# Attachment B - Staff Report

## City of Phoenix PLANNING AND DEVELOPMENT DEPARTMENT

### Staff Report Z-70-18-4 December 21, 2018

**Camelback East [Village Planning Committee](#) Meeting Date:** January 8, 2019  
**[Planning Commission](#) Hearing Date:** February 7, 2019  
**Request From:** [R-3](#) (0.94 acres)  
**Request To:** [R-4](#) (0.94 acres)  
**Proposed Use:** Multifamily Residential  
**Location:** Approximately 170 feet south of the southwest corner of 17th Street and Glenrosa Avenue  
**Owner/Applicant:** Ascend Properties  
**Representative:** Ashley Marsh, Tiffany & Bosco, PA  
**Staff Recommendation:** Approval, subject to stipulations

REVISIONS:  
JOB # 1812  
DATE: 9.16.2018  
CONTENTS: SITE PLAN  
SHEET NO: **SP100**

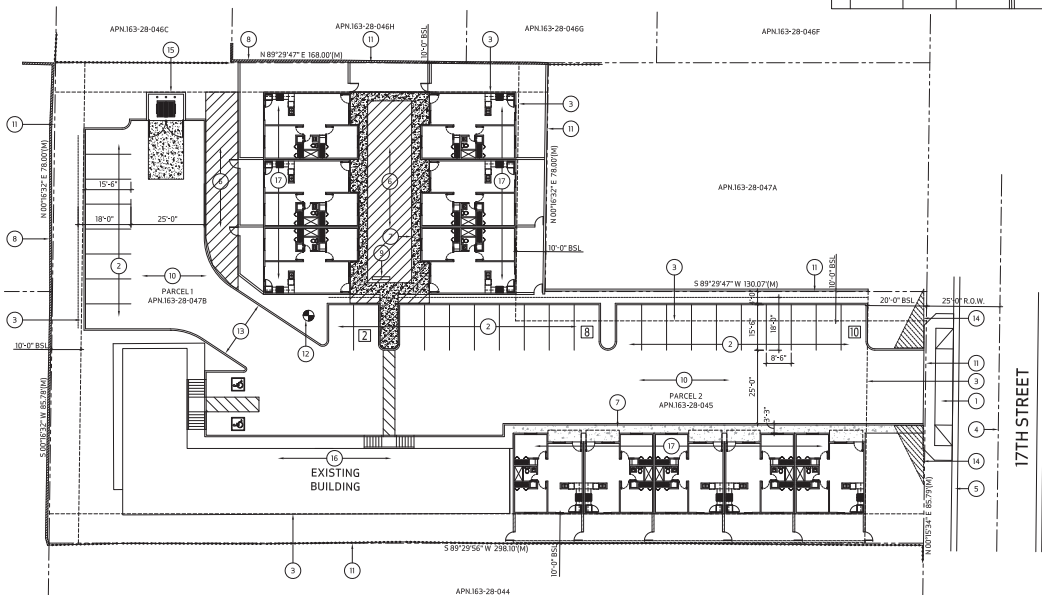
<b>R-4, Multifamily Residence District (Planned Residential Development Option)</b>		
<u><b>Standards</b></u>	<u><b>Requirements</b></u>	<u><b>Provisions on the Proposed Site Plan</b></u>
Gross Acreage	-	0.94
Total Number of Units	-	22 units
Dwelling Unit density (units/gross acre)	30.45; 34.80 with bonus	23.40 (met)
Lot Coverage	50% Maximum	27% (met)
Maximum Building Height	3 stories or 40 feet for first 150 feet, 1 foot in 5-foot increase to 48 feet, 4-story maximum	1-story, 20 feet (met)
<b>Building Setbacks</b>		
Perimeter (adjacent to street; 17th Street)	20 feet minimum	20 feet (met)
Adjacent to property line	10 feet minimum	North: 10 feet (met) South: 10 feet (met) West: 10 feet (met)
Front	10 feet minimum	N/A
<b>Landscape Setbacks</b>		
Street	20 feet minimum	Not provided
Adjacent to property line	5 feet minimum	North: 0 feet (not met) * South: 0 feet (not met) * East: not provided West: not provided

\*The site shall be modified to meet the requirement or a variance shall be obtained.

- 4. The conceptual site plan proposes a 22-unit multifamily development, an expansion of an existing multifamily development. The development proposes to add 11 new units to the existing 11 units. The existing development is two stories whereas the additional units are proposed to be single story. The existing parking carport to the north will be demolished and the area will be improved with additional dwelling units. The main access point to the site is through an existing driveway with access from 17th Street. Parking for the site will be located along the northern and western sides of the development.

The existing apartment complex contains mid-century modern elements. The new development should be compatible and harmonious with the existing development. Staff has included a stipulation requesting that the architecture, design, color and building materials of the new units be similar to the existing development. This is addressed in Stipulation No. 1. Staff is also requesting that all new units provide a covered entryway. The addition of covered entryways will provide visual interest from the street and provide shade for residents. This is addressed in Stipulation No. 2. Lastly, staff has requested that pedestrian walkways connect from the existing development to the new development and to the sidewalk and that the pedestrian pathways be clearly delineated through the use of contrasting material. This is addressed in Stipulation No. 3.

1. The architecture, design, color, and building materials shall be compatible for all of the buildings within the development, as approved by the Planning and Development Department.

2. Each new unit shall provide a covered entryway, as approved by the Planning and Development Department.
3. Pedestrian connections shall be provided to the street and from the existing building to the new buildings. All pedestrian walkways shall consist of a contrasting material such as decorative pavers, stamped or colored concrete, or another contrasting material, other than those used to pave the parking surfaces and drive aisles, as approved by the Planning and Development Department.

4. There shall be a minimum 5-foot-wide detached sidewalk along 17th Street with a minimum 5-foot-wide landscaped strip located between the sidewalk and back of curb and shall include a minimum 2-inch caliper shade trees planted a minimum of 20 feet on center or equivalent groupings along both sides of the sidewalk, as approved by the Planning and Development Department.

5. Minimum 3-inch caliper trees, planted 20 feet on center, or in equivalent groupings, shall be planted along the side yards adjacent to residential zoning to provide screening for adjacent residences, as approved by the Planning and Development Department.

6. The developer shall install secured bicycle parking at 0.25 spaces for each residential unit and a minimum of four inverted U-bicycle racks for guests located near entrances to the building, installed per the requirements of Section 1307.H. of the Zoning Ordinance, as approved by the Planning and Development Department.

7. The surface parking lot area shall be landscaped with a minimum 2-inch caliper shade trees. Landscaping must be dispersed throughout the parking area, as approved by Planning and Development Department.
